3.7 CAIB Recommendation 4.2-1 – Solid Rocket Booster Bolt Catcher

3.7.4 RTF TG Assessment

The bolt catchers were extensively redesigned after STS-107, and subjected to a full-range of qualification testing.

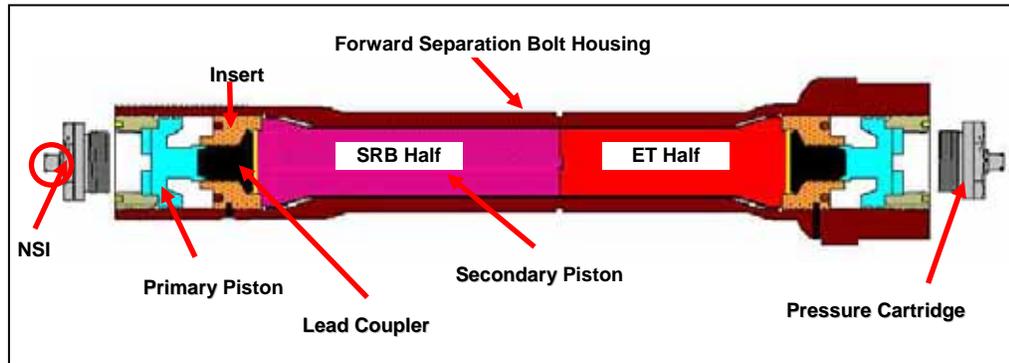
The bolt catcher for the SRB to ET separation bolt has been modified to provide an adequate safety factor, per the original specification. The STS-107 design was a two-piece welded assembly and the new design is based on a one-piece forging. The energy absorber used to attenuate the bolt impact load has been redesigned as well. Additionally, the thermal protection system has been changed from a sprayed-on material to bonded cork. The NASA standard initiator in the pressure cartridge had exhibited an ejection failure mode during several tests which could damage the energy absorber prior to bolt impact. This issue has been addressed by the incorporation of a locking ring assembly to aid in retention of the NSI.

The SRB bolt catcher has successfully completed qualification testing and has demonstrated a minimum structural factor of safety of 1.86. The new assembly was qualified by testing as a complete system to demonstrate compliance with NASA factor-of-safety and debris requirements. Additionally, the NSI retention device has been determined to exhibit a minimum factor of safety of 2.3. The redesigned bolt catcher has successfully completed Level IV DCR.
